City of Pembroke Pines
Planning & Economic Development Department
601 City Center Way 3rd Floor
Pembroke Pines FL, 33025

Agenda Date:	May 23, 2019	Application ID:	MSC 2019-09
Project:	Pembroke Isles Homeowners Association	Project Number:	N/A
Project Planner:	Cole Williams, Planner / Zoning Technician		
Owner:	Pembroke Isles Homeowners Association Inc.	Agent:	Grace Oliveros
Location:	1401 NW 169 Avenue		
Existing Zoning:	PUD (Planned Unit Development)	Existing Land Use:	Low 3 (2-3 du/acre) (L-3)
Reference Applications:	ZV 2012-06, MSC 2004-13, MSC 2003-16, SN 99-7, SP 98-24, SP 98-13, SP 98-11, SP 96-52, SP 96-09, SP 95-73, SP 95-31, SP 95-10		
Applicant Request:	Addition of a aluminum roof adjacent to the community clubhouse		
Staff Recommendation:	Approval		
Final:	<input checked="" type="checkbox"/> Planning & Zoning Board	<input type="checkbox"/> City Commission	
Reviewed for the Agenda:	Director: <u>MS</u>	Planning Administrator: <u>JY</u>

Grace Oliveros, agent is requesting approval for the addition of a aluminum roof and fencing adjacent to the existing Pembroke Isles community clubhouse located at 1401 NW 169 Avenue. The area under the proposed addition will be used to sto

NEW ALUMINUM ROOF FOR:
PEMBROKE ISLES CLUB HOUSE
1401 N.W. 169 AVE.
PEMBROKE PINES, FL.
CONTRACTOR: ALUMINUM OUTDOOR DESIGNS

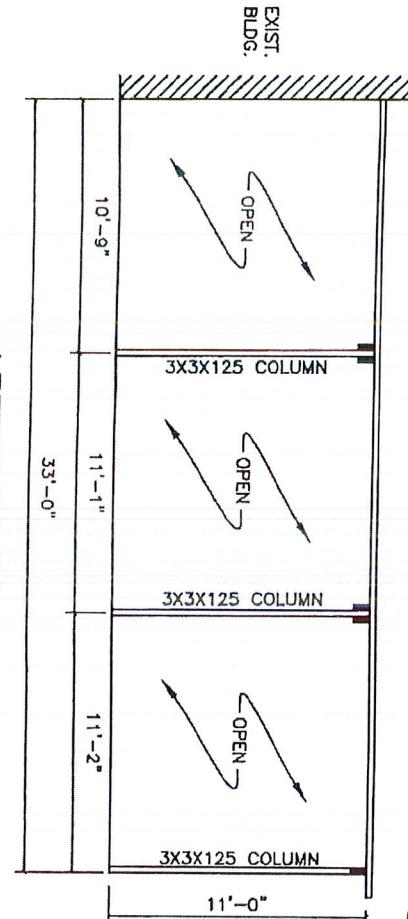
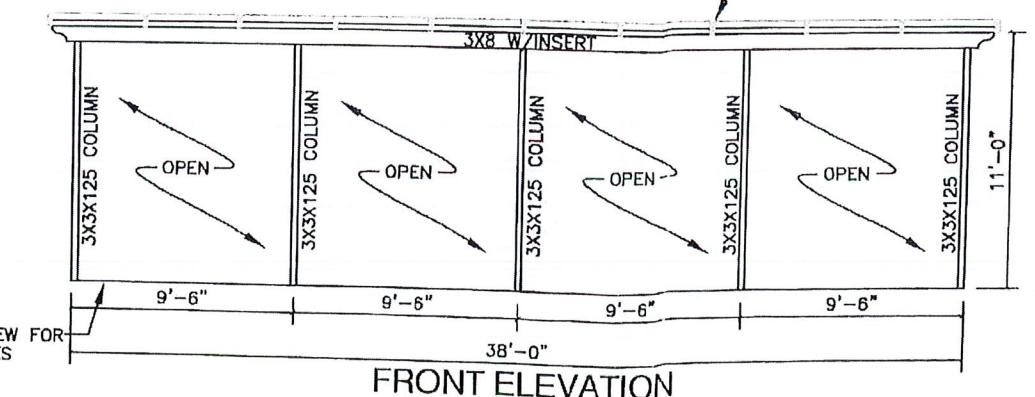
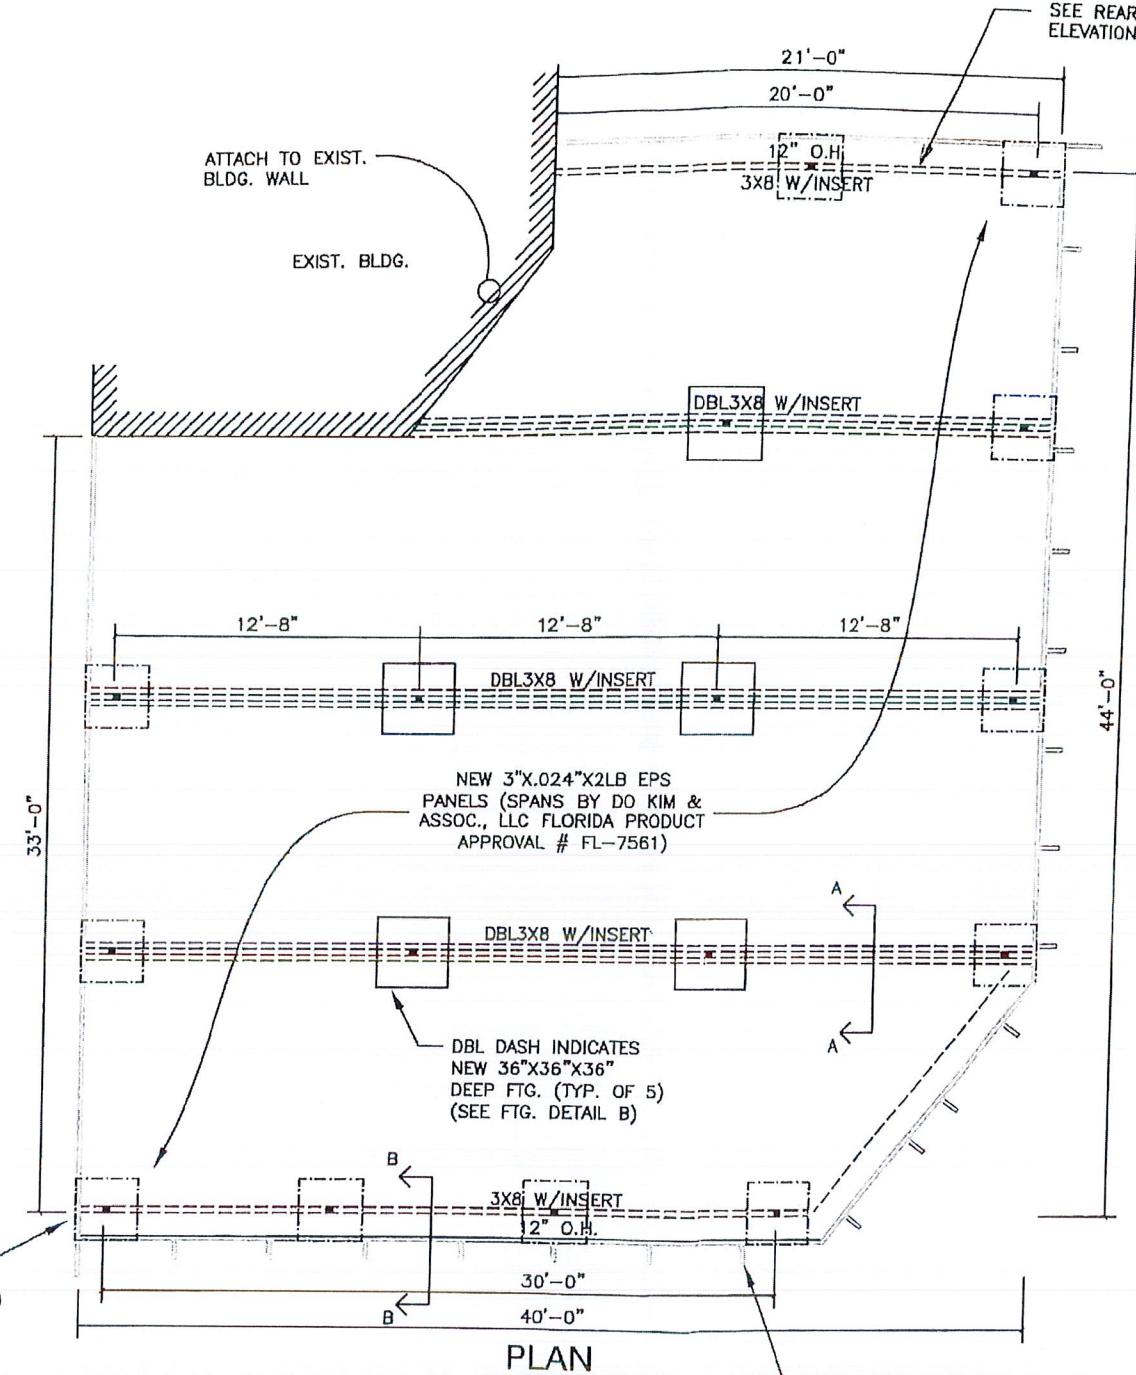
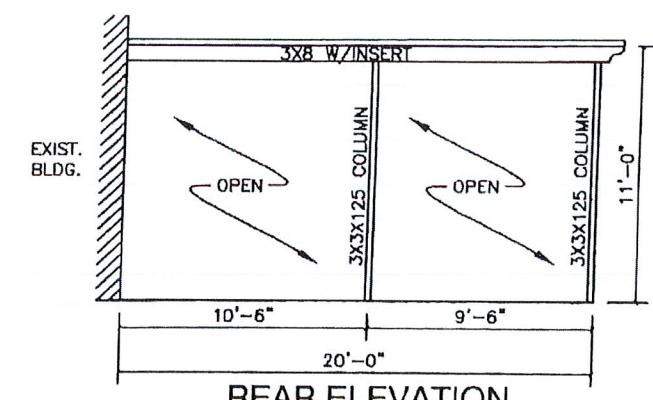
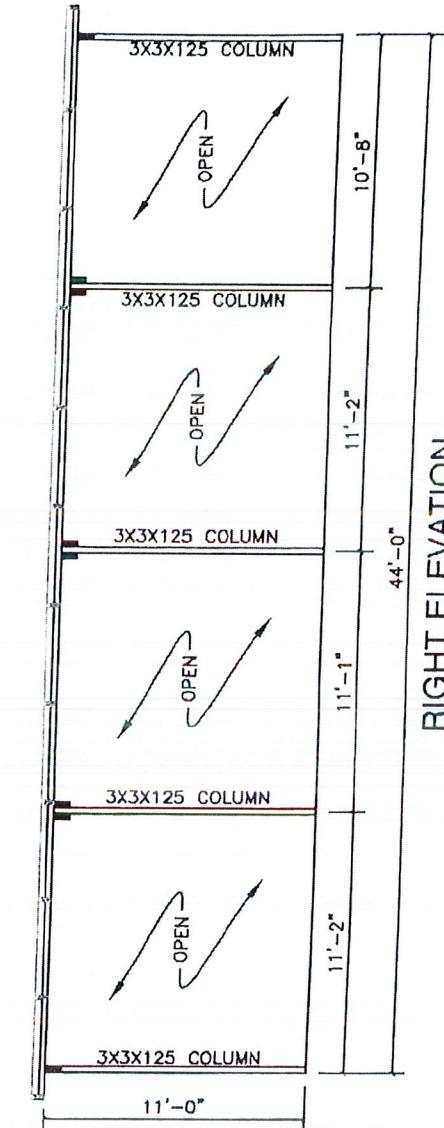
1. Provide all color numbers, color names, materials, finishes, etc. on elevations of structure.
2. Provide all details and elevations of fencing being used.
3. Landscaping along perimeter of enclosure for screening must be added.

1. Provide colors of cover and columns.
2. Is the cover illuminated?
3. Provide fence details (material, height, color).
4. What will the equipment be stored on top of (dirt, gravel, pavers, concrete, etc...)?

The applicant proposes a 1,497 square foot aluminum roof adjacent to the southeast corner of the existing clubhouse. The color of the roof and columns will be sand stone. A 6' tall black chain link fence is proposed around the structure to provide screening of the maintenance materials. Clussia will be planted adjacent to the fence to provide additional screening.

Landscaping

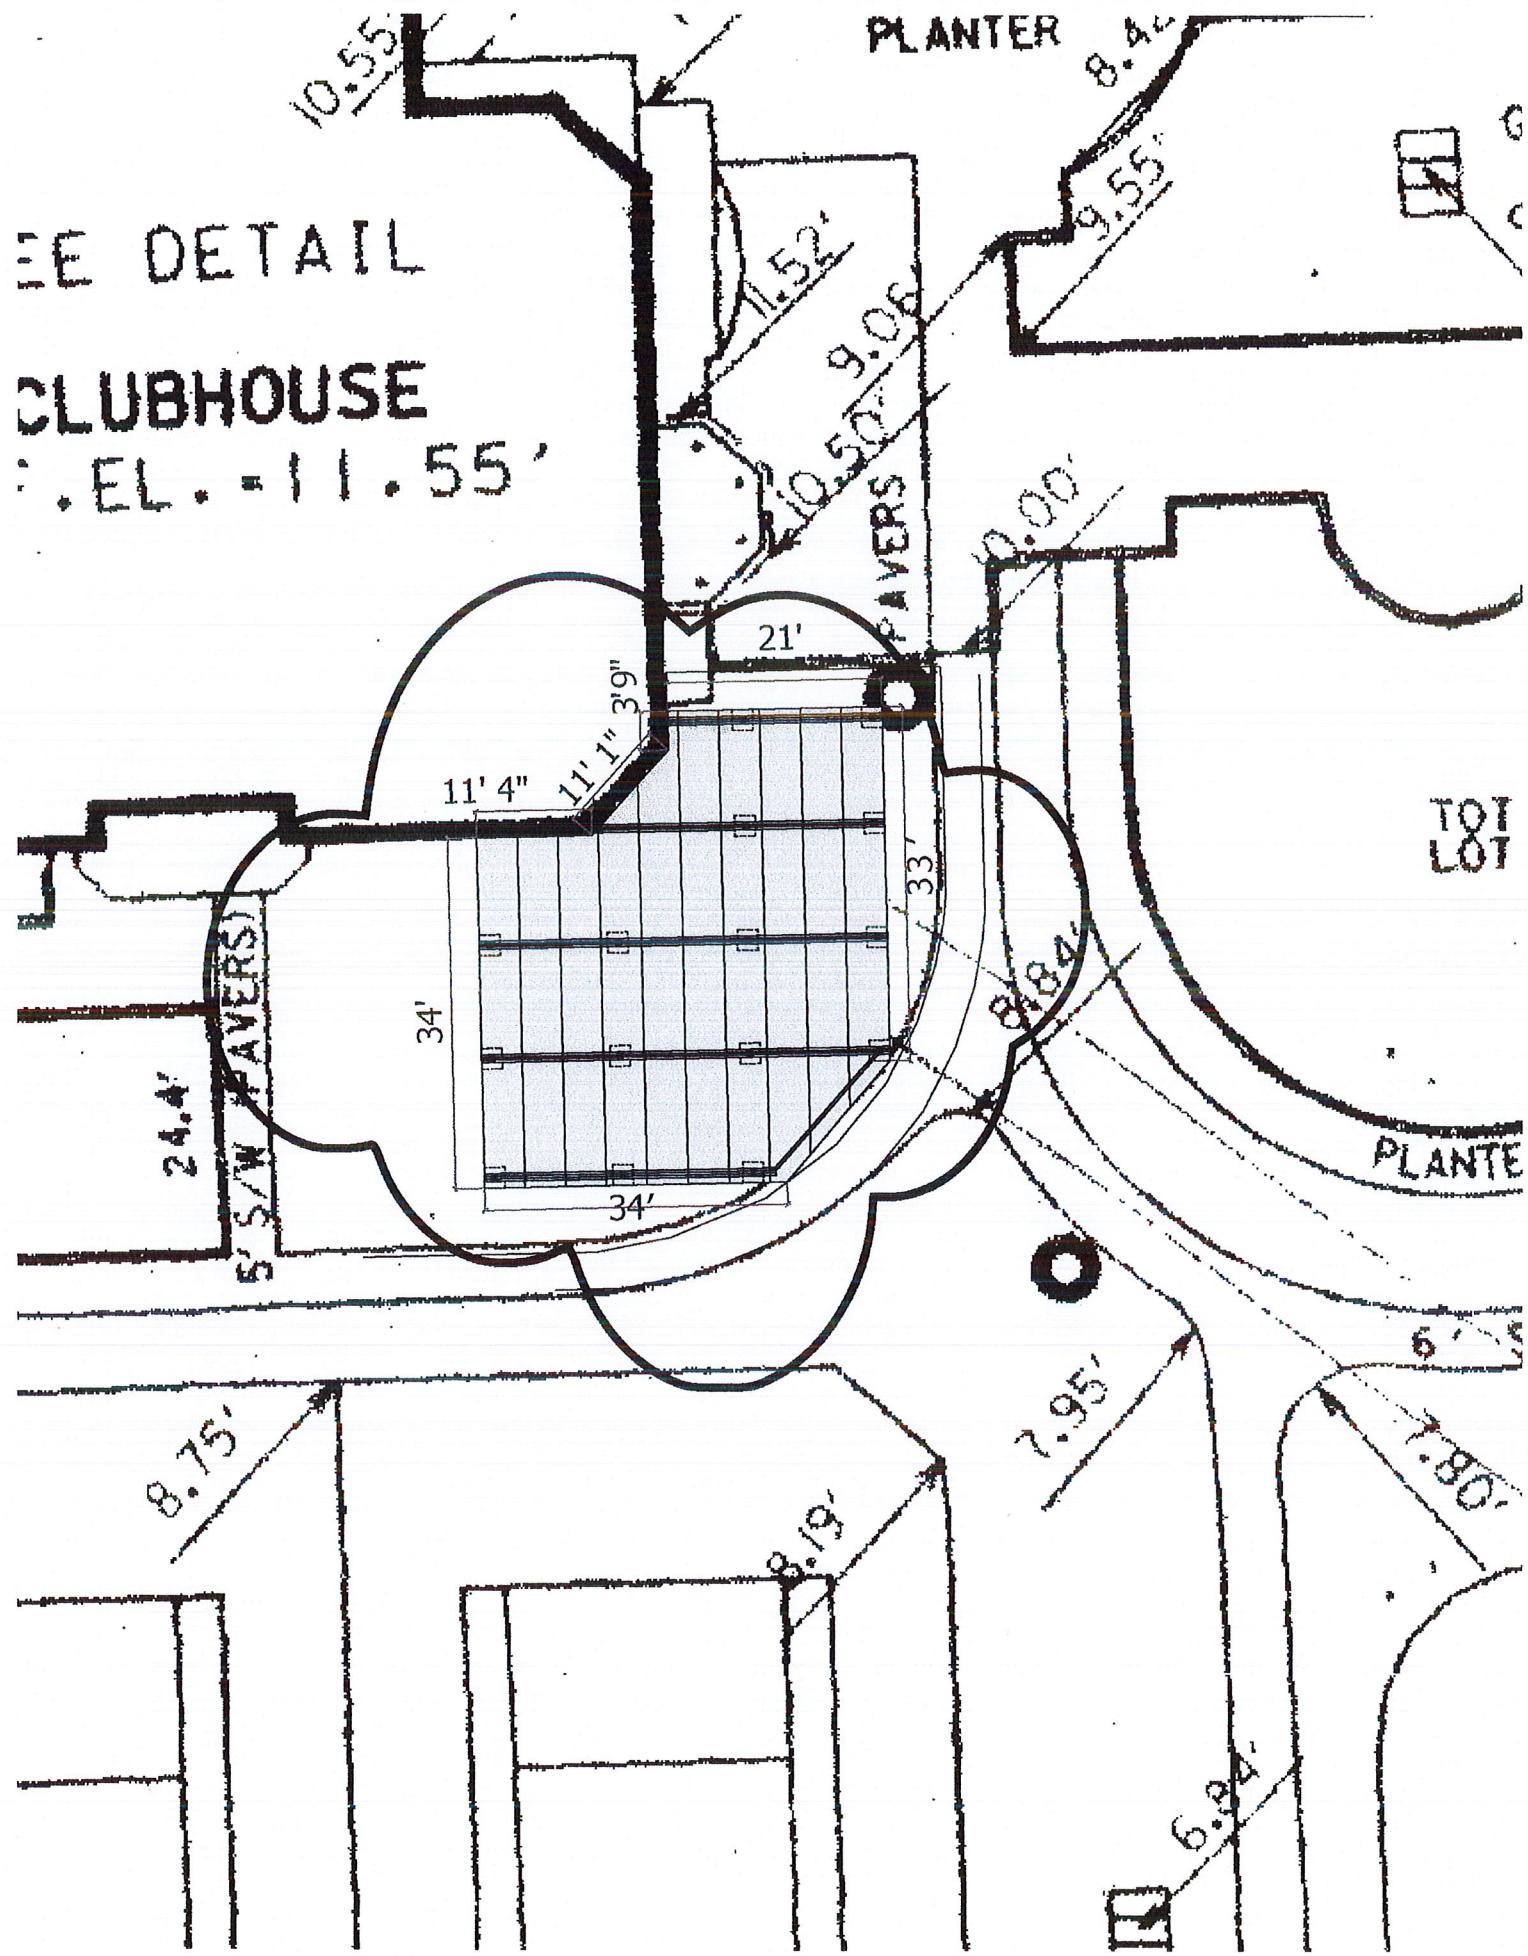
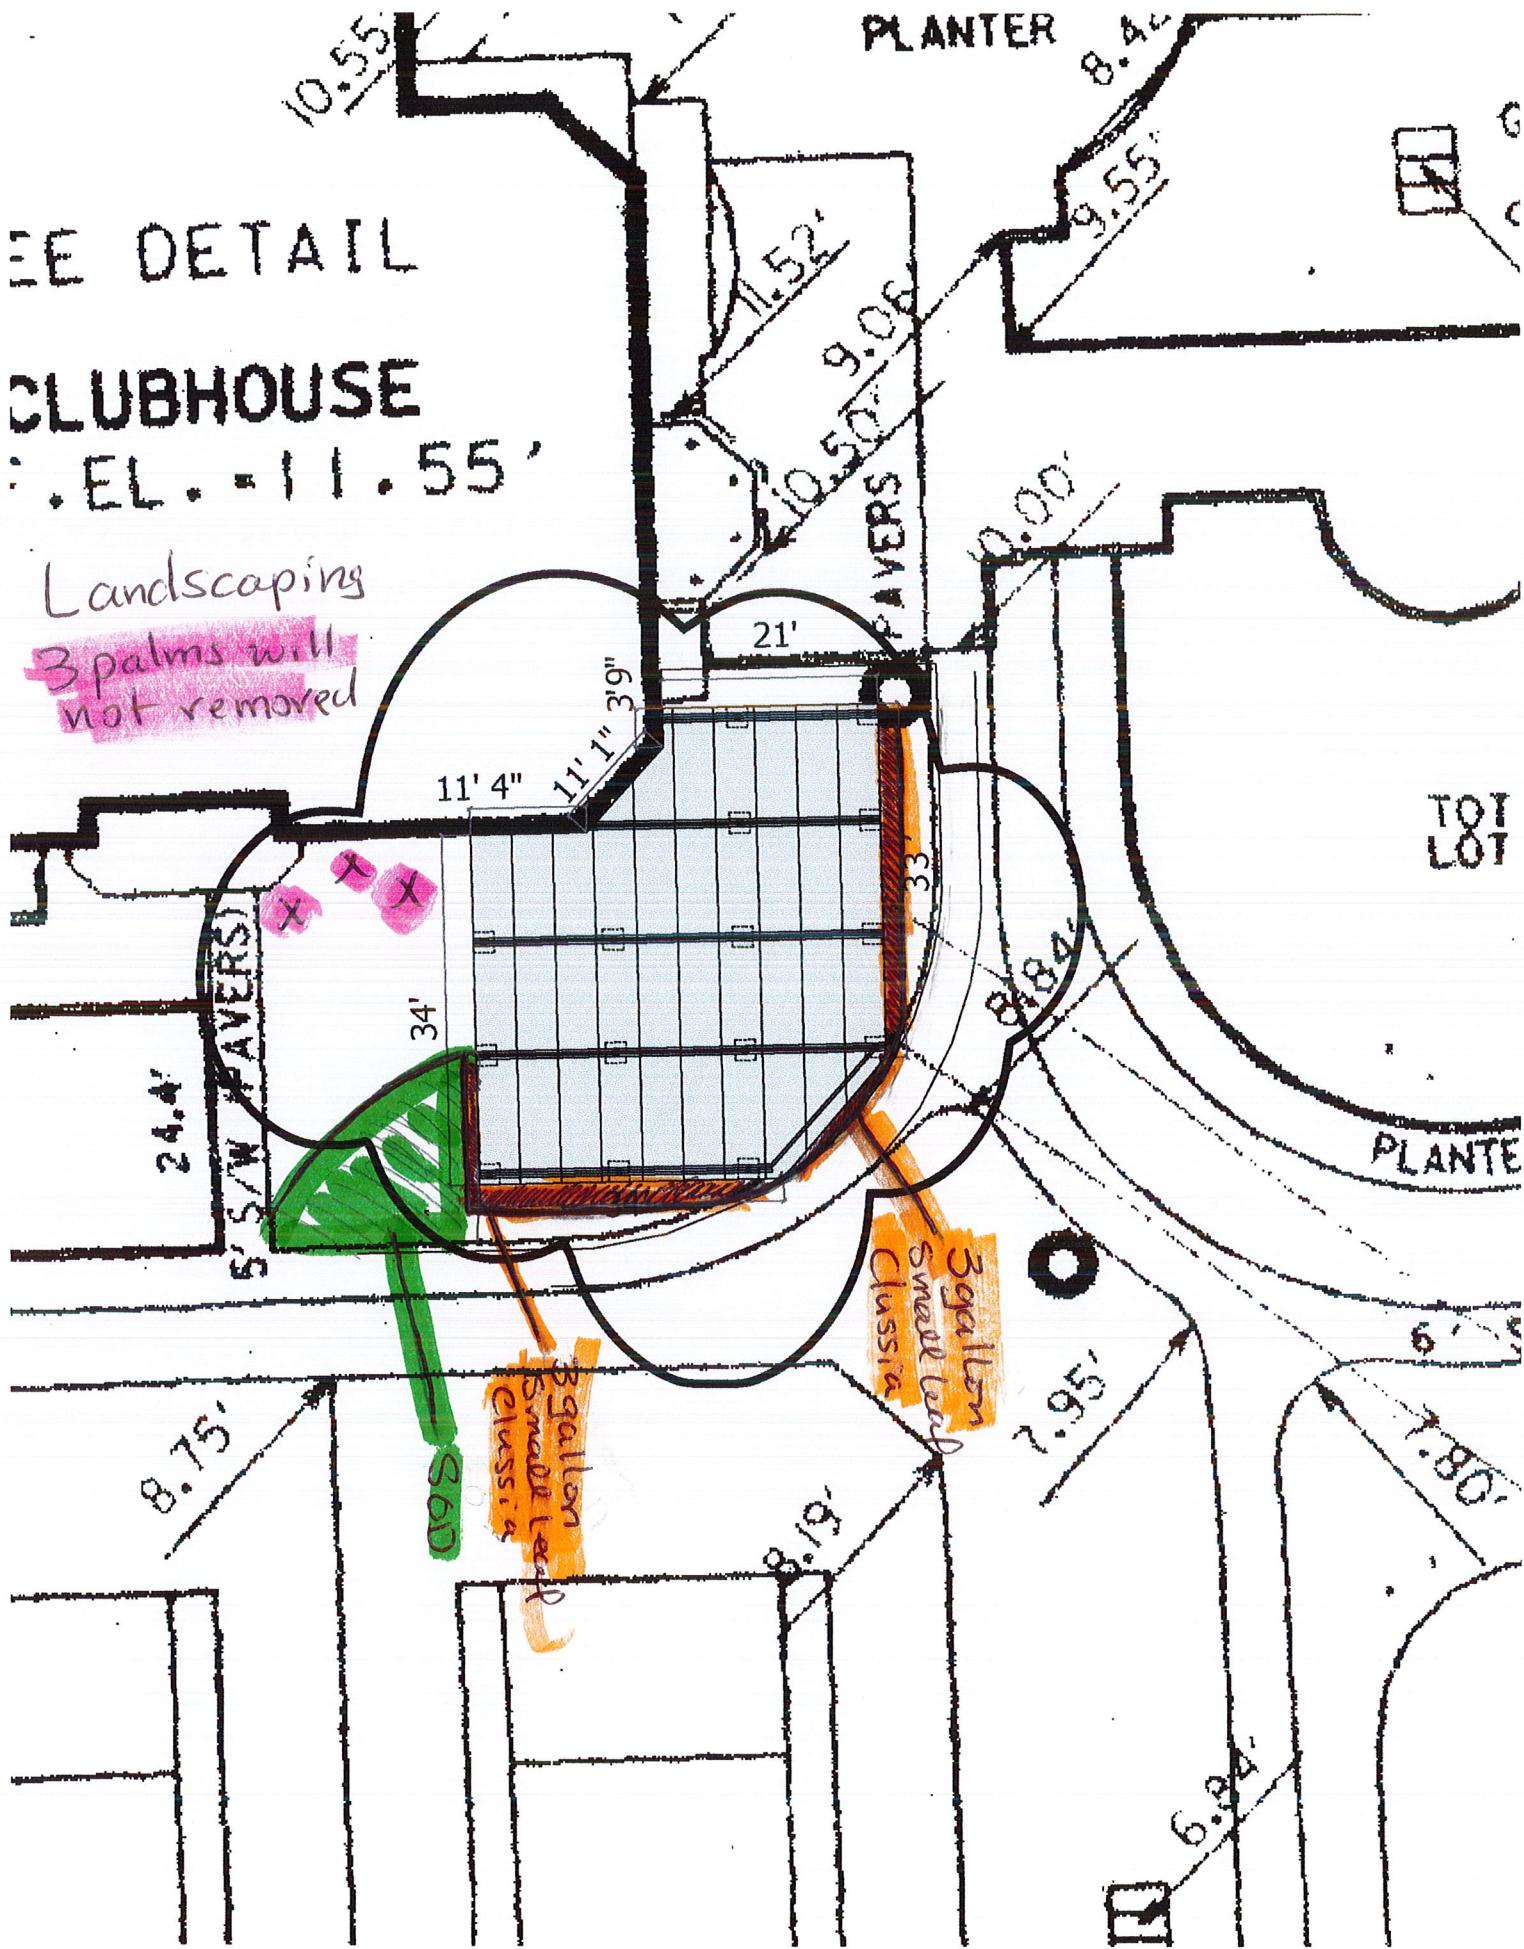
1. Please provide disposition and landscape plans.
2. As per City of Landscape Ordinance 153.11 (E) Utility structures, garbage, and refuse areas shall be screened with landscaping material to the extent that these areas are not visible at a maximum height of six feet from abutting properties or adjacent right-of-ways. Please add a landscape hedge to the perimeter of the fenced area.
3. If any trees or palm trees are scheduled to be removed please note that a tree removal permit is required along with proper mitigation of the plant material.
4. Irrigation must be repaired/installed properly to ensure that all new and existing landscape material is properly being irrigated. A "wet-check" shall be done at time of final inspection to ensure all irrigation heads are working properly etc.

3 palms will
not removed
